Request for Additional Information No. 553, Supplement 1

U. S. EPR Standard Design Certification

Question 06.03-18:**Open Item****Follow-up to RAI 416, Question 6.3-15**

Figure 06.03-18-1–IRWST Liquid Temperature

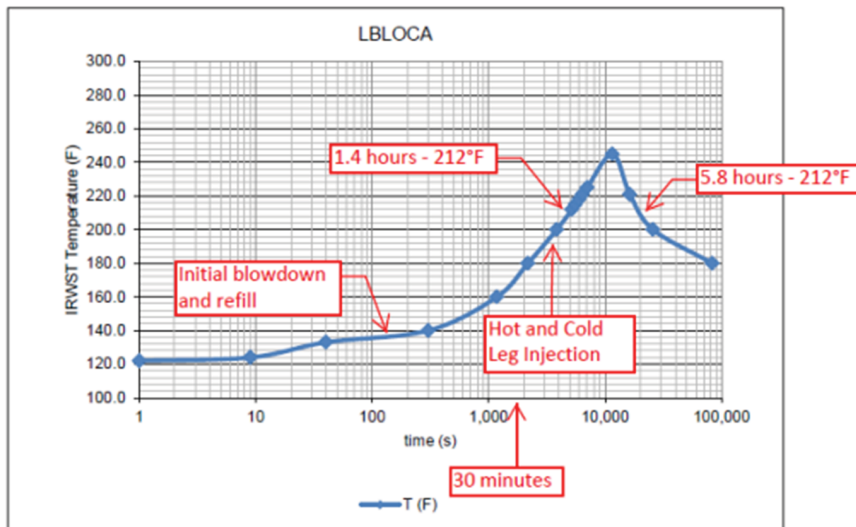
To complete the staff evaluation of the 6.3 SER Phase 2 Open Item 06.03-15 in support of ECCS pump performance, the staff request that AREVA address guidance contained in SECY 11-0014 and provide key NPSH information in FSAR section 6.3 that identifies the limiting or worst case NPSH evaluation for the ECCS pumps with justification for the selected data. At a minimum, the staff expects the FSAR to contain the limiting ECCS pump NPSH evaluation, to include the following parameters and plots, and to specify the basis for the ECCS pump flowrate selected and NPSH_r uncertainty. Note, all heads and pressures should be expressed in feet of liquid at the pumping temperature selected for the evaluation.

To facilitate understanding of the post-LOCA (loss of coolant accident) sequence of events, the heatup and subsequent cooldown of the in-containment refueling water storage tank (IRWST) is shown in Figure 06.03-18-1—IRWST Liquid Temperature for the large break loss of coolant accident (LBLOCA).

After the initial blowdown and refill, decay heat increases IRWST temperature until the heat removal rate of the LHSI heat exchangers matches the rate of decay heat as shown in Figure 06.03-18-1. The head equivalent to the vapor pressure of the water varies with temperature. U.S. EPR FSAR Tier 2, Section 6.3.3.3, NPSH Evaluation, will be revised to provide additional description of the evaluation of the $NPSH_a$ during this period.

The first part of the NPSH evaluation considers the period without operator action as the IRWST heats up and then the interval in the low NPSH margin range that is approximately two hours for LHSI. Therefore, the time of greatest susceptibility to cavitation erosion is very limited. Figure 06.03-18-1 shows that IRWST temperatures were above 200°F for approximately six hours.

Figure 6.3-8—LHSL in LB LOCA

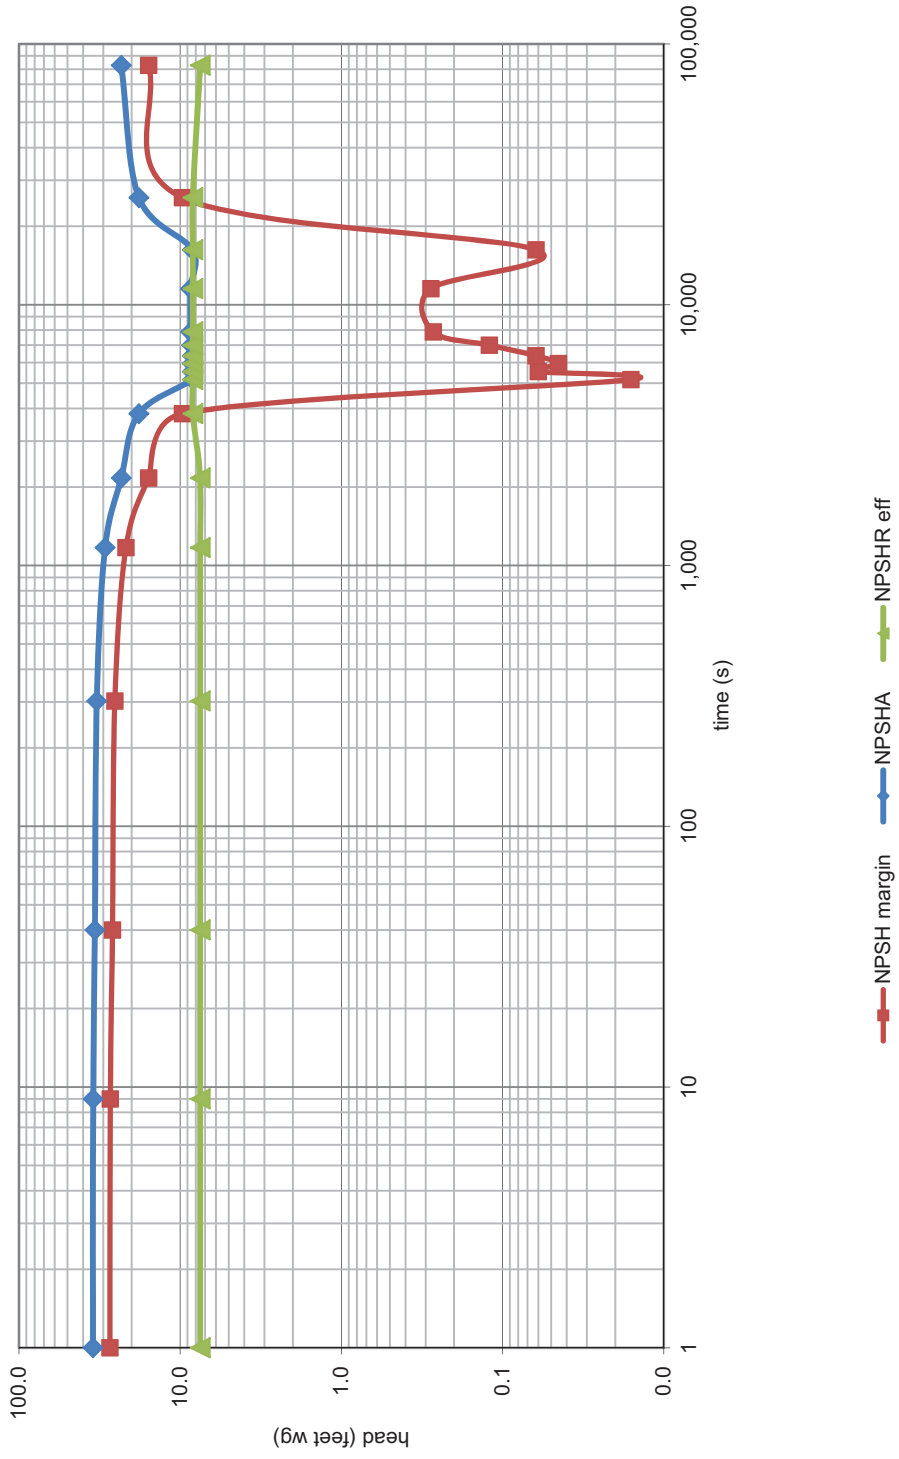
- Line/friction loss (feet)
- Atmosphere Pressure (feet)
- Vapor Pressure of liquid at pump suction (feet)
- NPSH_{reff} where $NPSH_{reff} = (1 + \text{uncertainty}) \times NPSH_r \times 3\%$
- Plot of NPSH_a and NPSH_{reff} vs. Time

New U.S. EPR FSAR Tier 2, Figure 6.3-8—LHSI in LB LOCA and Figure 6.3-9—MHSI in LB LOCA, will be provided to show NPSH over time for the LHSI and MHSI pumps, respectively.

Generic pump tests indicate that the zone of maximum cavitation erosion rate lies between NPSH margin ratios of 1.2 to 1.6 according to NRC SECY-11-0014. The NPSH margin over time where NPSH ratio is between 1.2 and 1.6 are shown in new U.S. EPR FSAR Tier 2 Figure 6.3-8 and Figure 6.3-9.

Large NPSH margin exists during the blowdown and refill phases, as shown in U.S. EPR FSAR Tier 2, Figure 6.3-8—LHSI in LB LOCA and Figure 6.3-9—MHSI in LB LOCA. At approximately one hour into the event operator action to align LHSI flow, required for simultaneous cold-leg and hot-leg injection and stop MHSI flow, is taken to limit pump runoff. This corresponds to the slightly positive LHSI pump NPSH margin.

Note: The NPSH Margin and NPSHA curves in U.S. EPR FSAR Tier 2, Figure 6.3-8 exhibits what appears to be a slight discontinuity around 2000 seconds. This apparent discontinuity has been evaluated and verified to result from the Excel curve plotting application attempting to plot a smooth curve on a log-log scale plot. There is no data error associated with this plot.

The most limiting case for NPSH for the LHSI pump is 2925 gpm during simultaneous injection, saturated liquid in the IRWST, and saturation pressure both in containment and at the break at 212°F as shown in Figure 6.3-8—LHSI in LB LOCA. For this case, the MHSI pump is switched off so the LHSI pump discharge flow rate equals the total suction flow rate. The results are:
